STAFF RECOMMENDATION
1907 Beechwood Avenue
March 20, 2019

Application: New Construction—Addition; Setback Determination; Partial Demolition.
District: Belmont-Hillsboro Neighborhood Conservation Zoning Overlay
Council District: 18
Base Zoning: RS7.5
Map and Parcel Number: 10416023700
Applicant: Kaitlyn Smous, Nine12 Architects
Project Lead: Melissa Baldock, melissa.baldock@nashville.gov

Figure 3. The original structure on the lot is marked in red. It was at the back of the lot. The front house was added in 1989

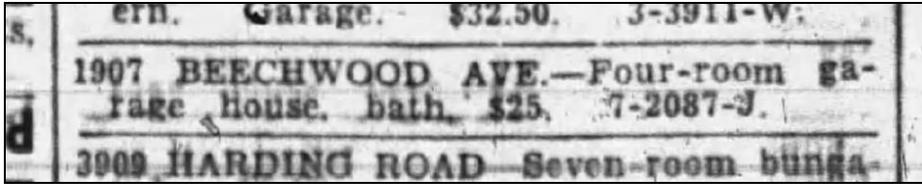
The house was constructed at the rear of the lot, but it was never an accessory structure to another house (Figure 3). It was always the primary structure on the lot. Staff’s research into the deeds for this lot and the abutting lots showed that this lot and the adjoining lots were deeded separately to different owners as early as 1919, prior to their improvement. It is not known why this house was constructed at the rear of the lot, but staff has found several other historic houses in the Hillsboro-West End and Belmont-Hillsboro neighborhoods that were constructed in the 1920s and 1930s and were situated at the back of the lot. Other examples include 1724 Linden Avenue, 2121 Westwood Avenue, 2514 Ashwood, and 2807 27th Avenue South, just to name a few. These houses were sometimes referred to as “garage houses” in real estate advertisements, although many of them, including 1907 Beechwood, likely did not contain a garage (Figure 4).

Figure 6 (left) shows the addition that is to be demolished. Figure 7 (right) is the 1934 Sanborn Map.

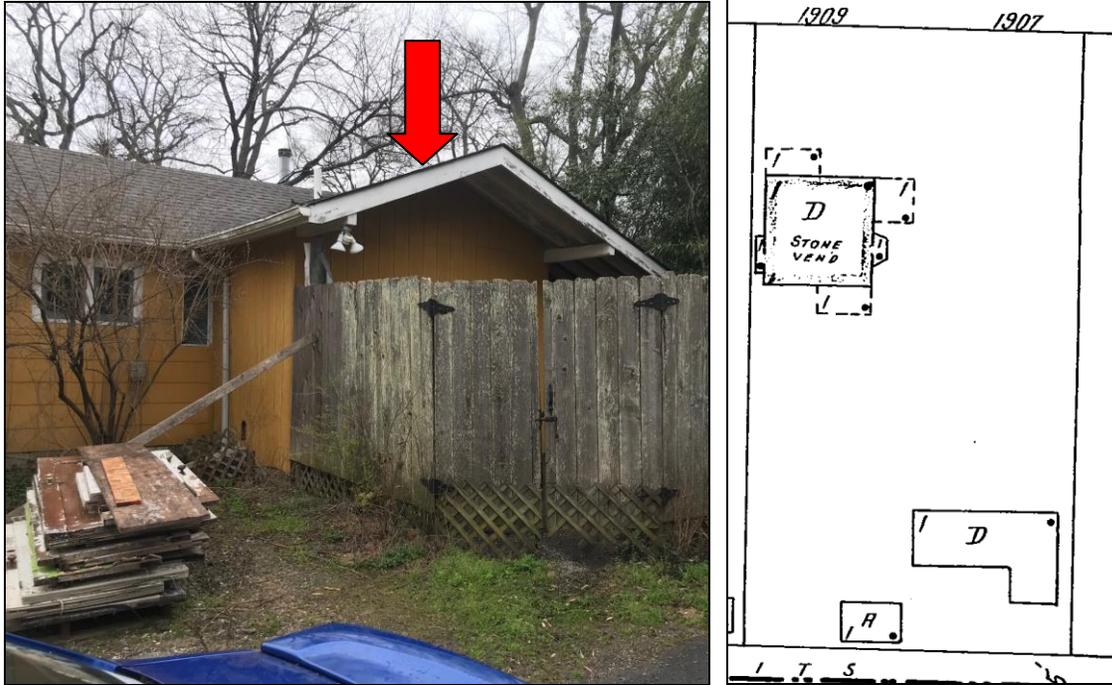
Demolition: The applicant intends to remove a rear portion of the house (Figure 6). The 1931 Sanborn maps shows that there was a rear extension in this general area historically (Figure 7). However, the rear portion that is existing today seems to have been reconstructed sometime in the last few decades. Also, this rear extension is not visible from the street and is not an integral part of the historic house's architecture and design. Staff therefore finds that the demolition of the rear portion of the house meets Section V.2. of the design guidelines.

ELEVATIONS
A2.0

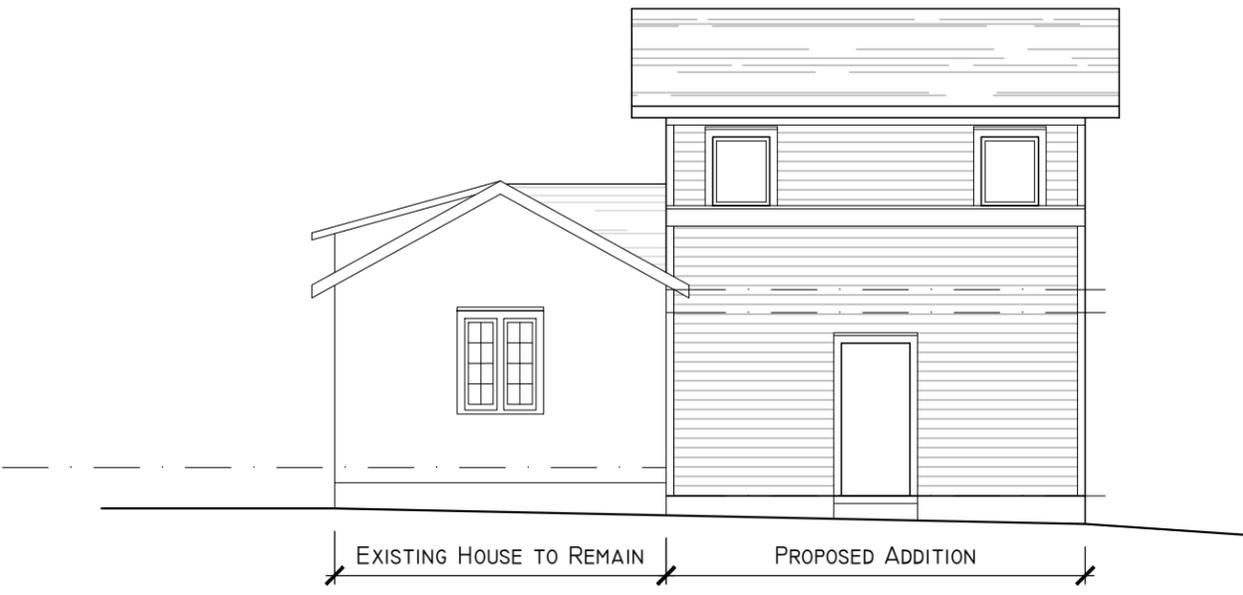
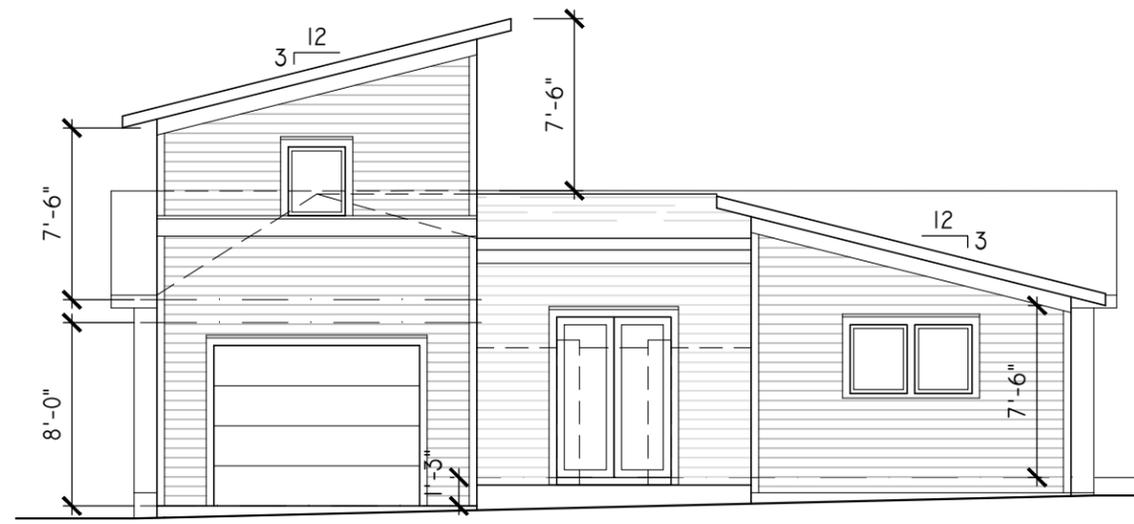
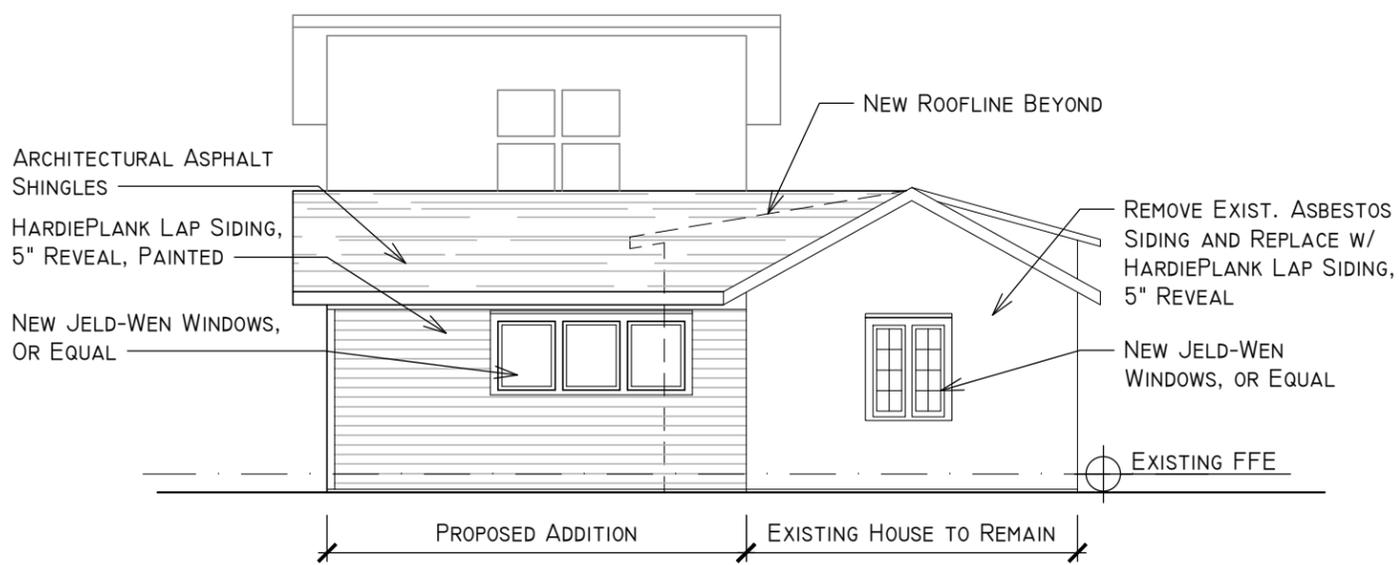
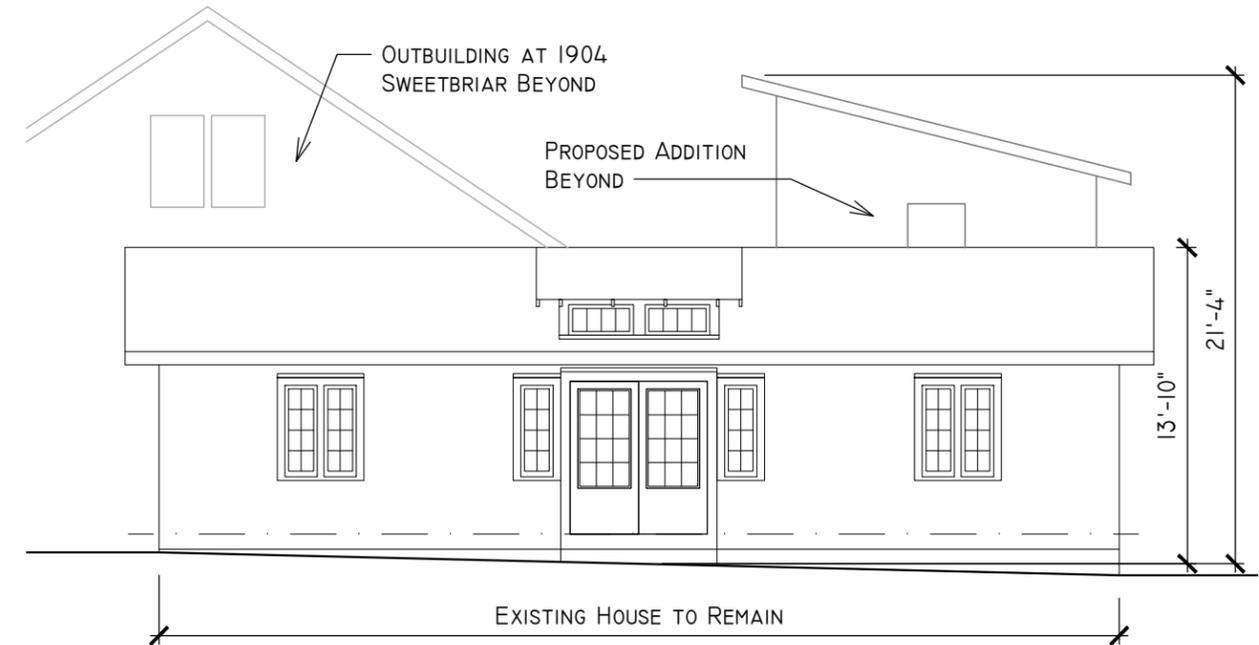
Height & Scale: The addition is inset one foot (1') from both back corners of the house, which staff finds to be appropriate. On the right side, the addition is one-story and its eave, foundation, and ridge heights match those of the historic house, which staff finds to be appropriate.

On the left side, the addition is two-stories tall and approximately seven feet, eight inches (7'8") taller than the historic house. On a typical house in an historic or neighborhood conservation zoning overlay, the height and scale of this addition would not be appropriate. However, this house is not typical for several reasons. One, the house was constructed at the rear of the lot, but is now largely obscured by the house added to the front of the lot. In addition, because the house is located at the rear of the lot, the footprint of any rear addition is limited. The addition's footprint is just five hundred and fifty-eight square feet (558 sq. ft.). The tall addition will not be highly visible from the street, particularly since the designer has limited the width of the two-story portion to just fourteen feet (14'). Also, the two-story portion allows for extra square footage as the footprint of the addition is constrained because of the house's location at the back of the lot. The addition's height, while taller than the historic house at the back of the lot, is no taller than the house at the front of the lot. In addition, at twenty-one feet, four inches (21'4"), it is several feet shorter than what the Commission allows for outbuildings typically constructed in this location.

Roof form: The historic house has a side gable roof form and a front shed dormer. The proposed addition will have shed roof forms with 3/12 slopes. For the one-story portion, the shed roof form is no taller than the historic house and will not be visible from the street. The two-story shed roof form may be partially visible from the street, but staff finds that is appropriate given the location of the house at the rear of the lot and the fact that the addition will not be highly visible from the street.

Staff finds that the proposed roof forms meet Section II.B.1.e. and II.B.2. of the design guidelines.
